**Road vehicles — Anchorages in vehicles  
and attachments to anchorages for child  
restraint systems —**

**Seat bight anchorages and attachments**

**AMENDMENT 3: Specifications for the  
detection of use of ISOFIX CRS**

Reference number  
ISO 13216-1:1999/Amd.3:2006(E)

Figure 8.1 — Maximum dimensions of the connector

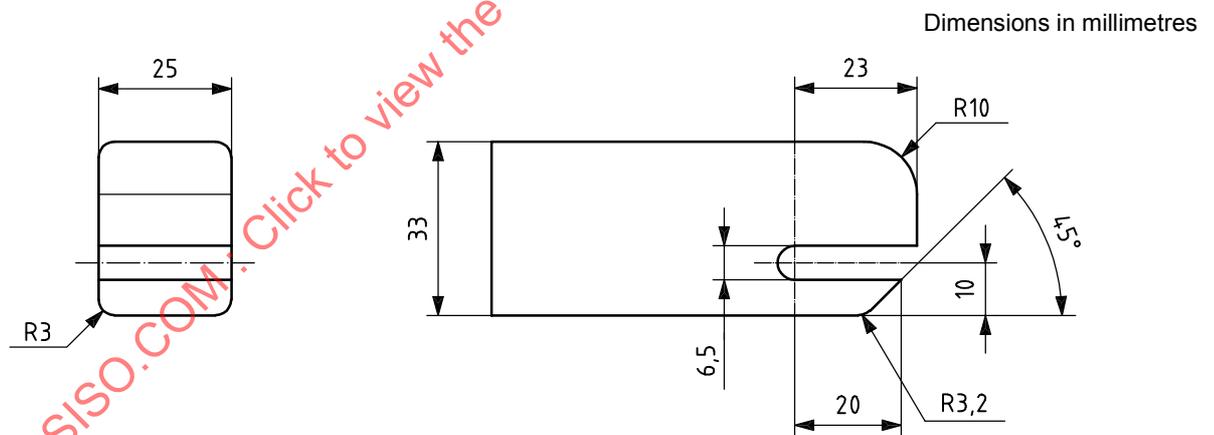
Page 12, 5.2.2

Modify 5.2.2 as follows.

Dimensions for the portion of the CRS connector that engages the anchorage bar shall not exceed the maximum dimensions given by the envelope in Figure 8.1 and not be less than minimum dimensions given in Figure 8.2.

**Figure C.1 — Detection test apparatus — side and plan views**

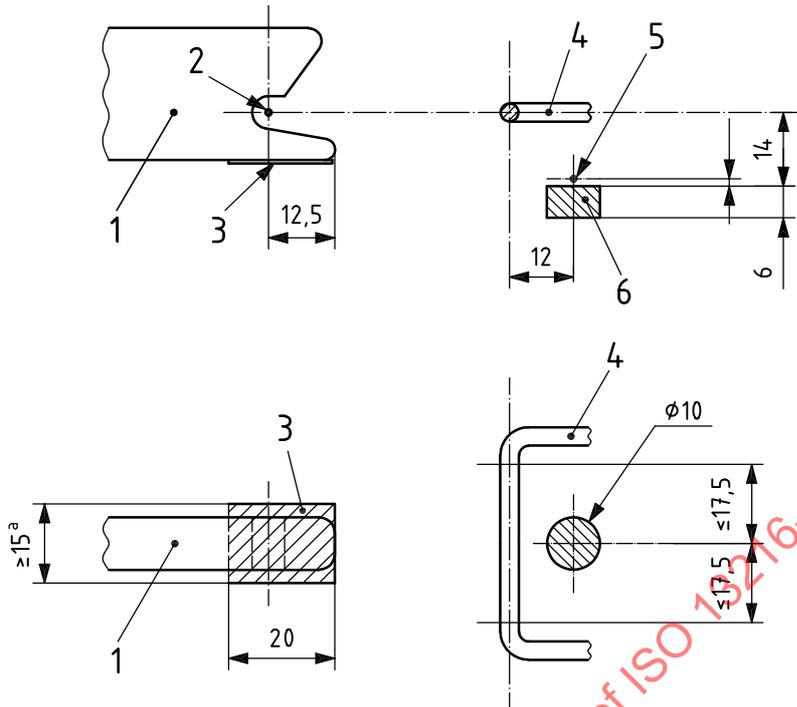
After Annex B, page 18, add Annex C as follows.

The present annex is applicable to ISOFIX CRS and specifies a method to detect the use of such ISOFIX CRS into vehicles.

The principle of detection is based on the variation of a magnetic field when the ISOFIX connector of the child seat moves forward the ISOFIX anchorage bar of the vehicle.

See Figure C.1.

**Figure C.2 — Induction graph**

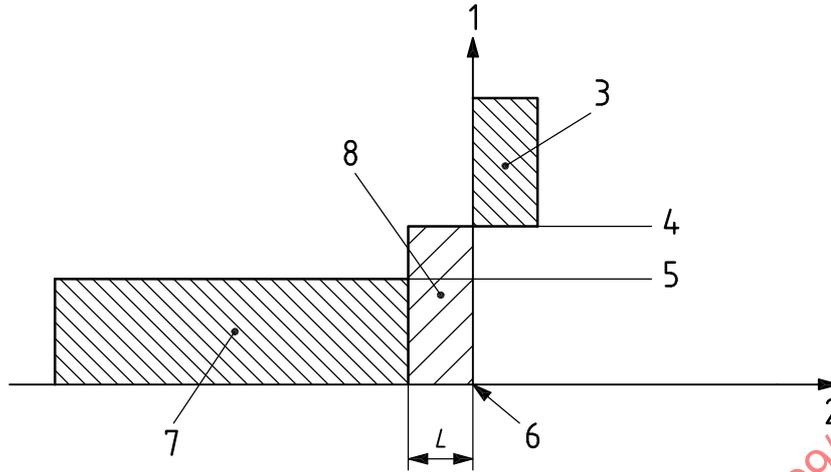
- 1 induction at point A
- 2 point B position
- 3 ISOFIX connector detected
- 4  $F_2 \approx 0,115 T$
- 5  $F_1 \approx 0,110 T$
- 6 ISOFIX anchorage axis
- 7 ISOFIX connector non detected
- 8 area in which the ISOFIX connector presence cannot reliably be determined
